HOPE CREEK GENERATING STATION
DOCKET NO. 50-354
DRAFT SAFETY EVALUATION REPORT
OPEN ITEM STATUS

Attachment 1 is a current list which provides a status of the open items identified in Section 1.7 of the Draft Safety Evaluation Report (SER). Items identified as "complete" are those for which PSE&G has provided responses and no confirmation of status has been received from the staff. We will consider these items closed unless notified otherwise. In order to permit timely resolution of items identified as "complete" which may not be resolved to the staff's satisfaction, please provide a specific description of the issue which remains to be resolved.

In addition, enclosed for your review and approval (see Attachment 4) are the resolutions to the Draft SER open items listed in Attachment 3, and per your request in the July 30, 1984 meeting with the Geosciences Branch, Attachment 5 contains a copy of our comments (telecopied to

Figure 1 Soil Column for Evaluation of Hope Creek Site Spectra

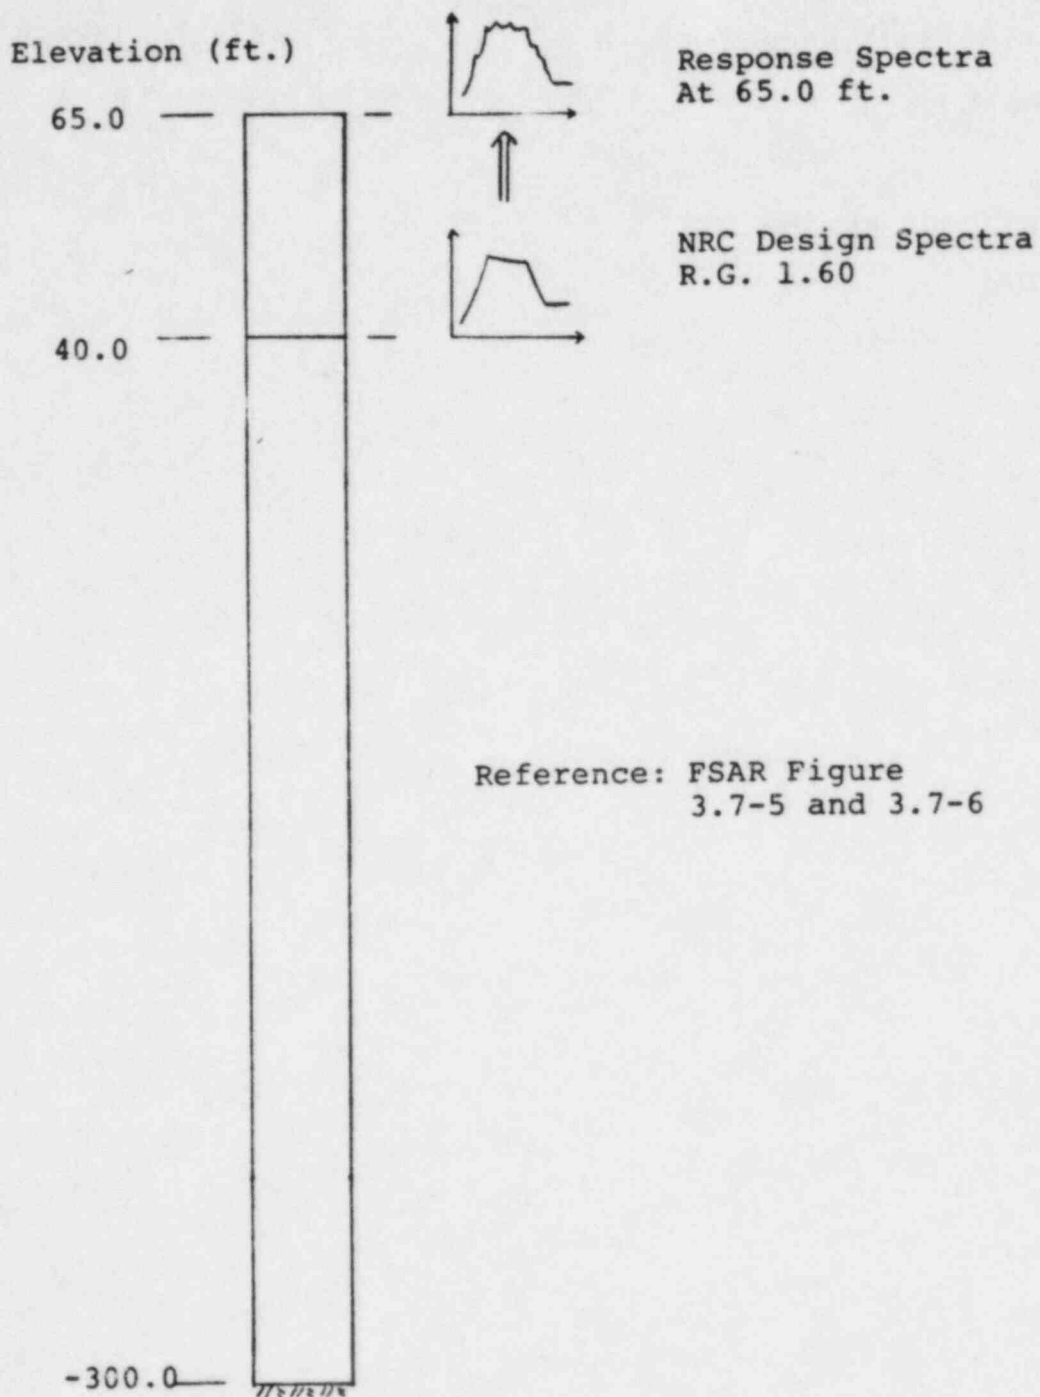
- i. A free-field soil column as shown in Figure 1 is used in deconvolution analysis. The top of the soil column is truncated at elevation 65.0 ft since the soil below this elevation (Kirkwood and Vincentown formation) has shear wave velocity of approximately 1,850 ft/sec which are comparable to the site condition of the LLNL Study. FLUSH computer code is used for the soil column analysis (Reference 2).

- i. The soil column as shown in Figure 1 is used for the evaluation of the Hope Creek vertical site spectra. Due to the presence of water table near the ground surface, the compression wave velocity of soil is appropriately adjusted for the vertical analysis.

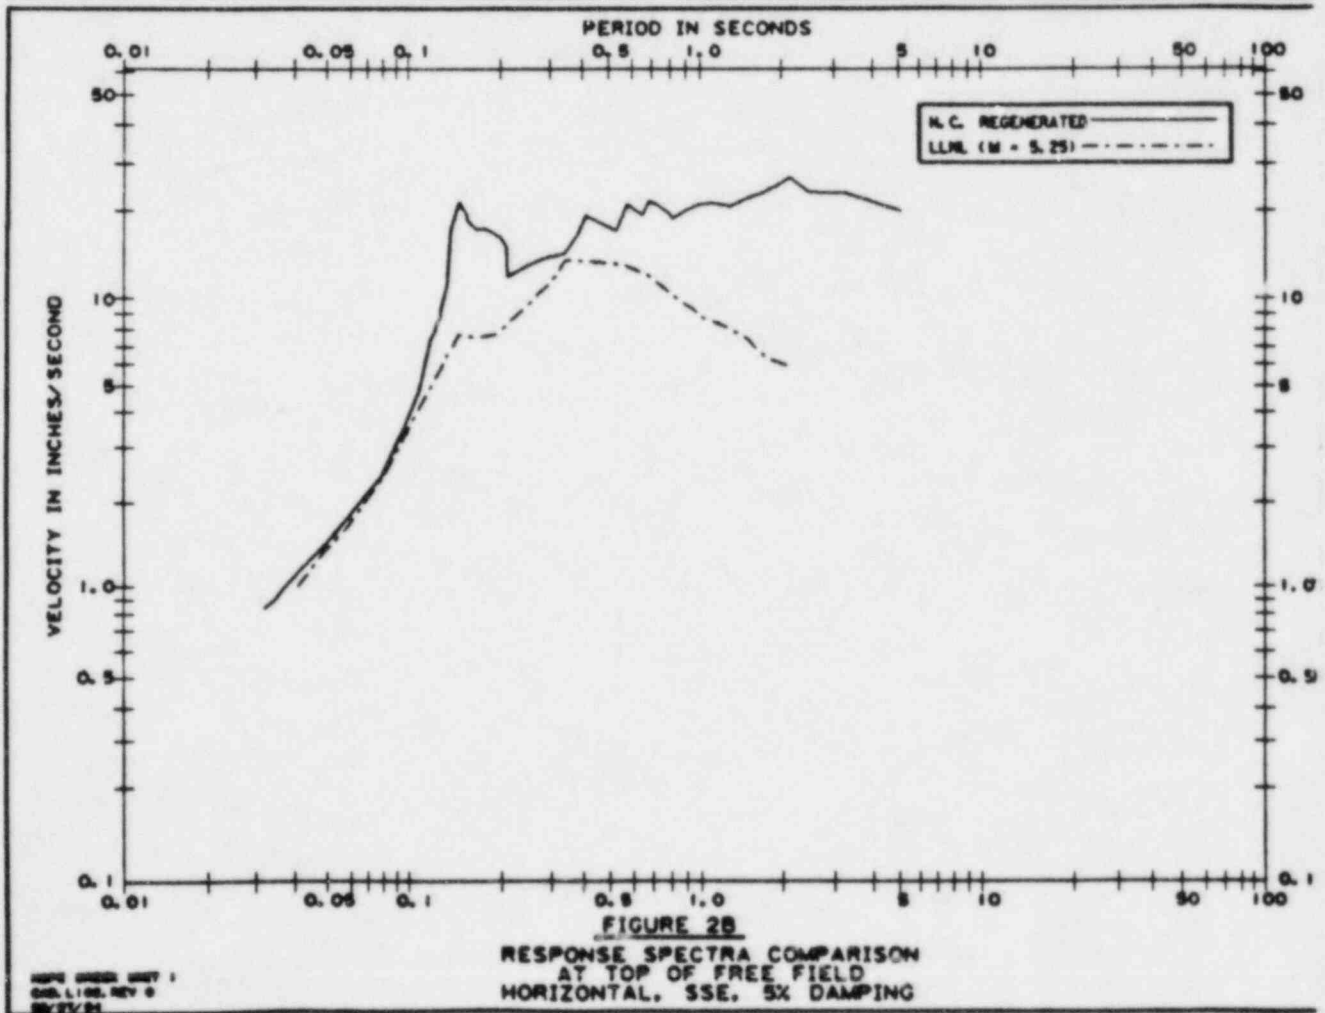
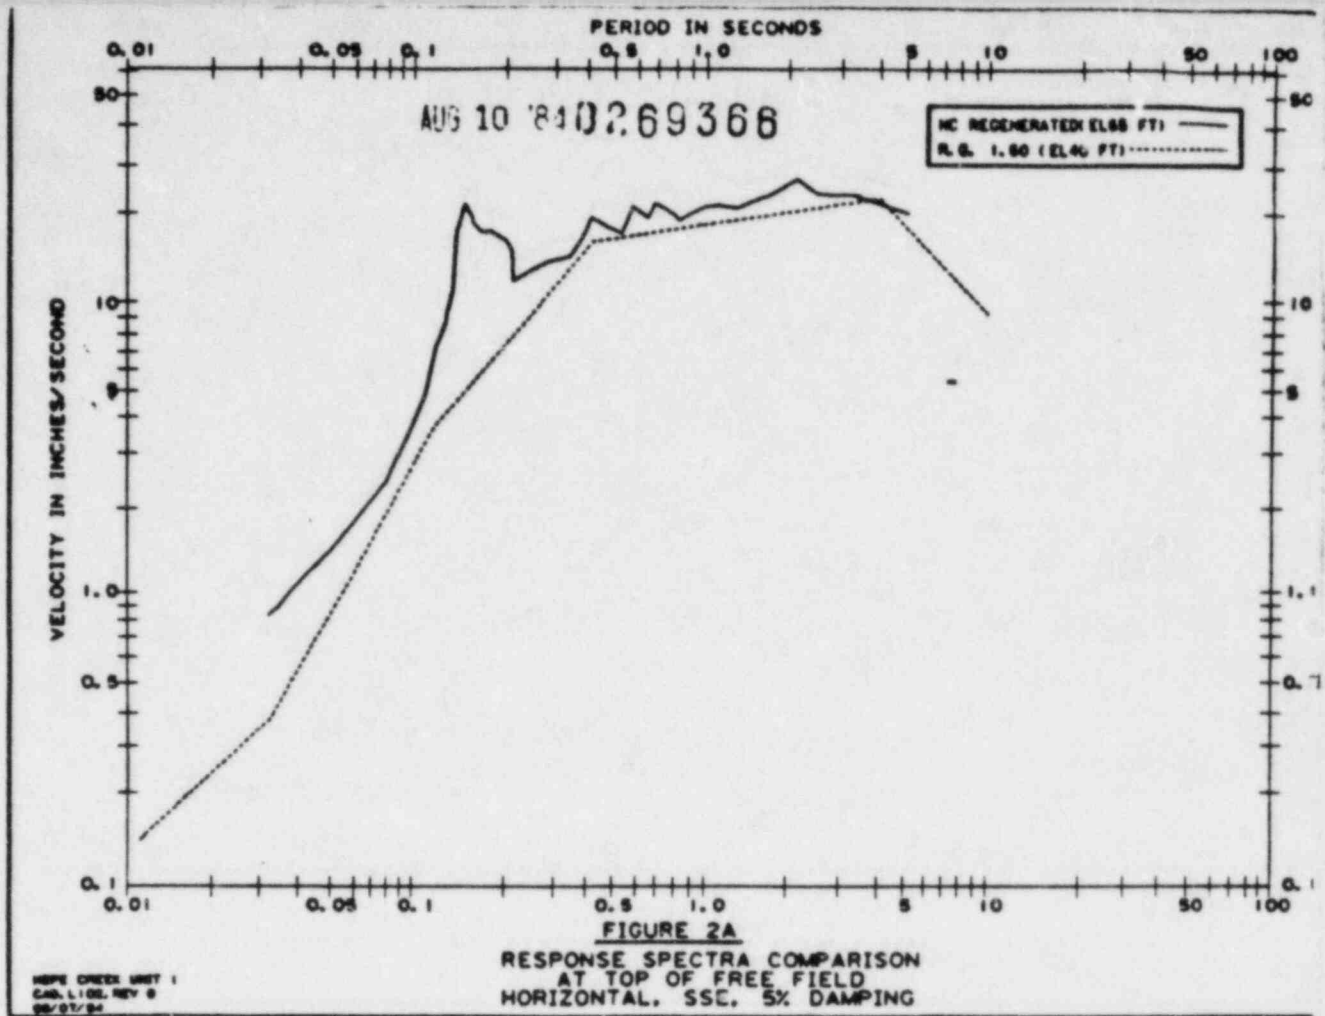
- ii. The Hope Creek design spectra are applied at elevation 40.0 ft where the power block foundation is located and the response spectra (5% damping) at the top of the soil column are generated. Figure 2A shows the comparison plots between the regenerated spectra at the top of the soil column and the input spectra delineating amplification effect. Figure 2B shows comparison between the LLNL spectra ($m_b L_g = 5.25$) and the regenerated design spectra.

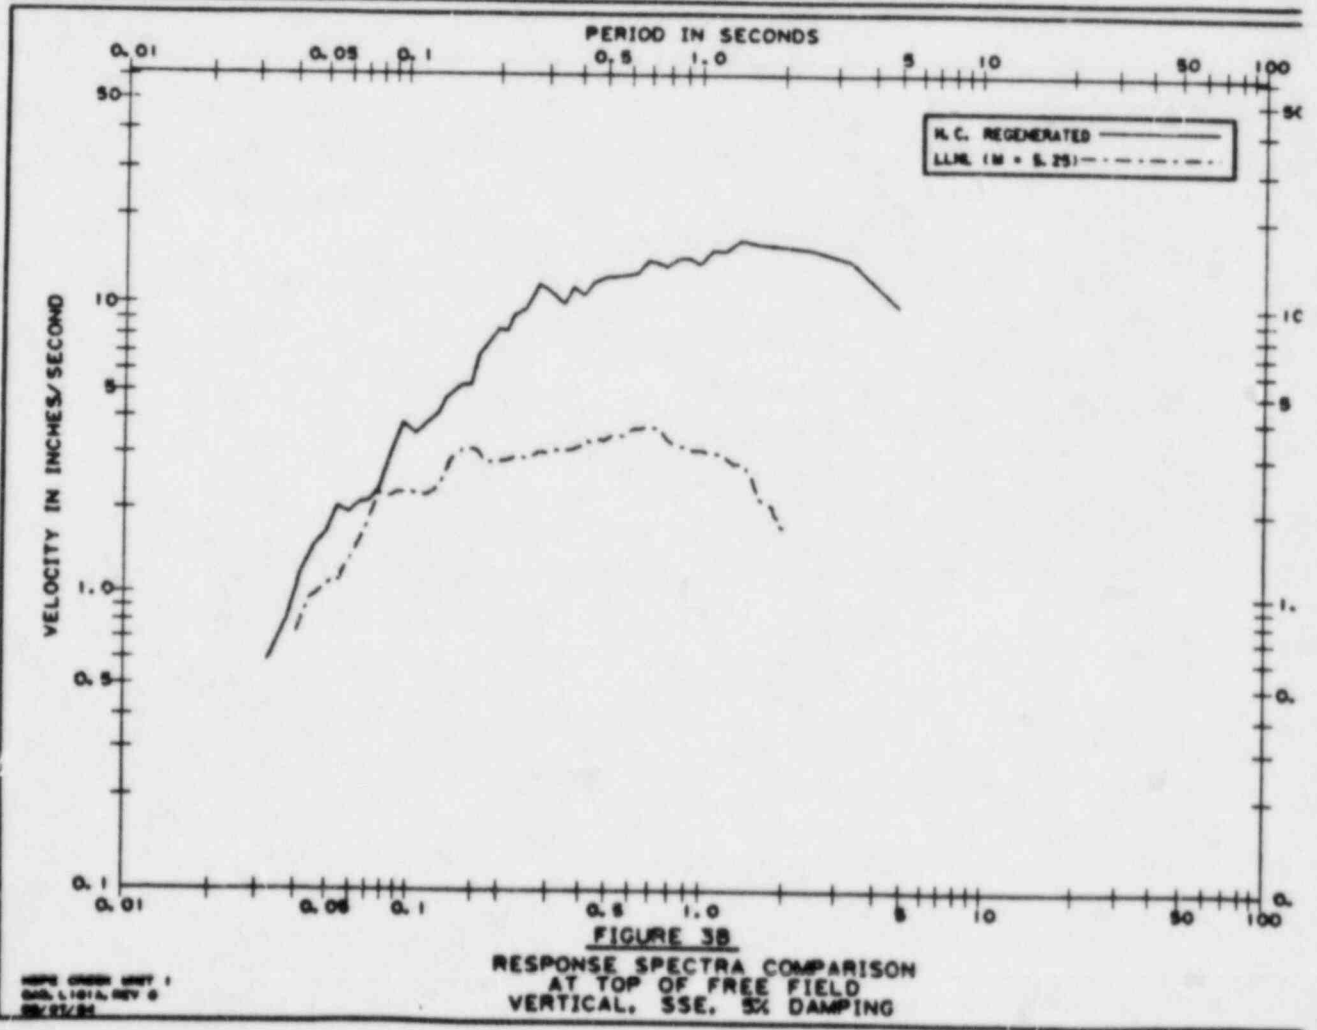
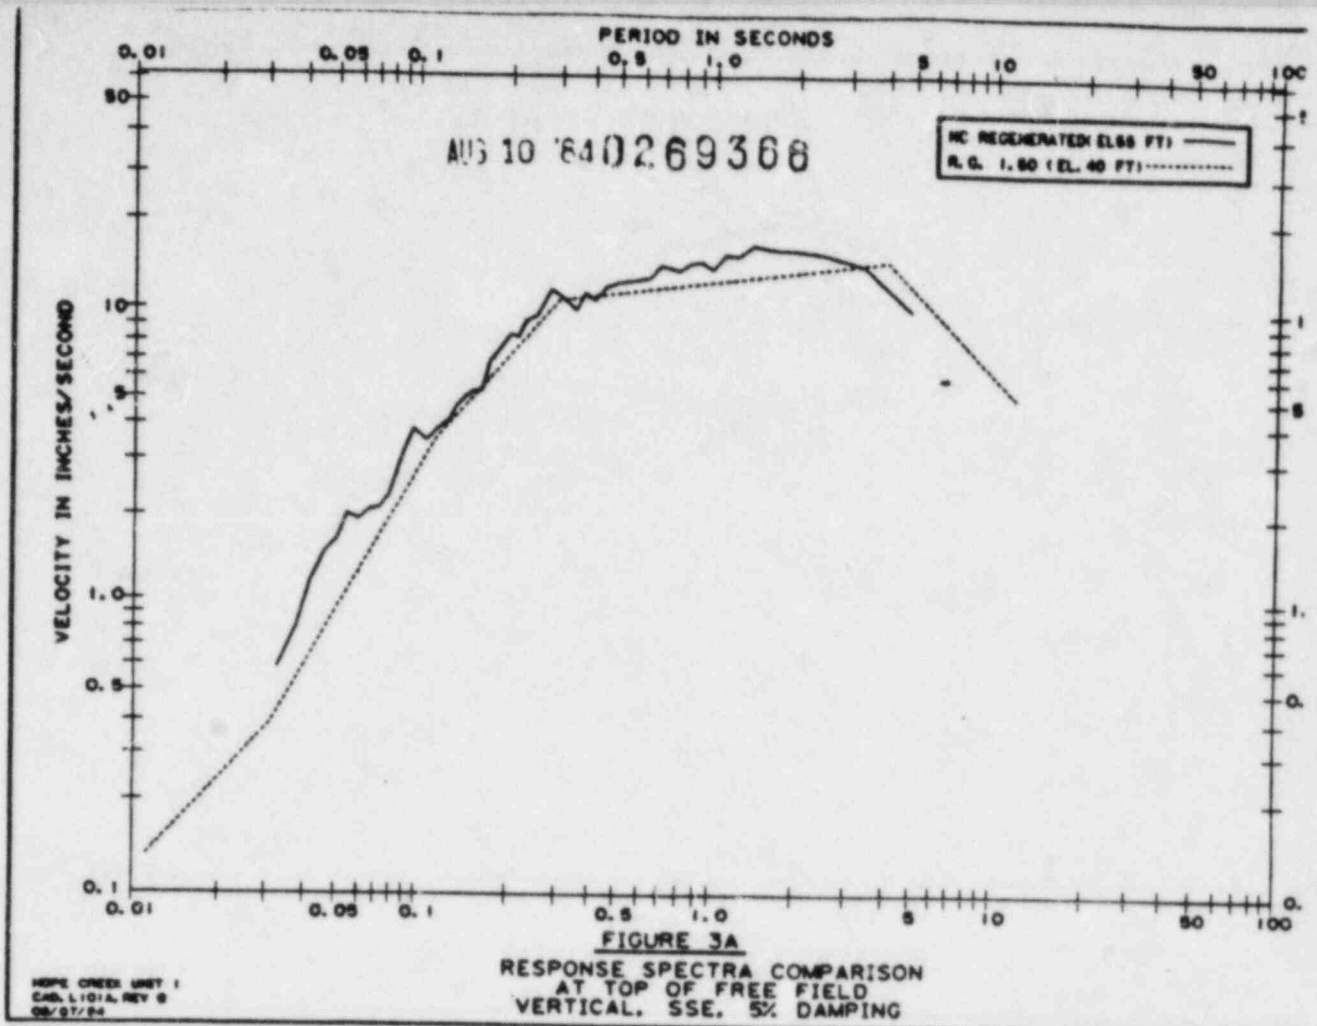
- ii. The Hope Creek design response spectra are applied at elevation 40.0 ft of the soil column and the corresponding response spectra are regenerated at elevation 65.0 ft.
- iii. Figure 3A shows the comparison plots between the velocity response spectra at the top of the soil column and the input spectra delineating amplification effect. Figure 3B provides the comparison between LLNL spectra and the equivalent regenerated Hope Creek spectra. The Hope Creek spectra envelop the LLNL spectra. Therefore, it is concluded that the Hope Creek input spectra are adequate.
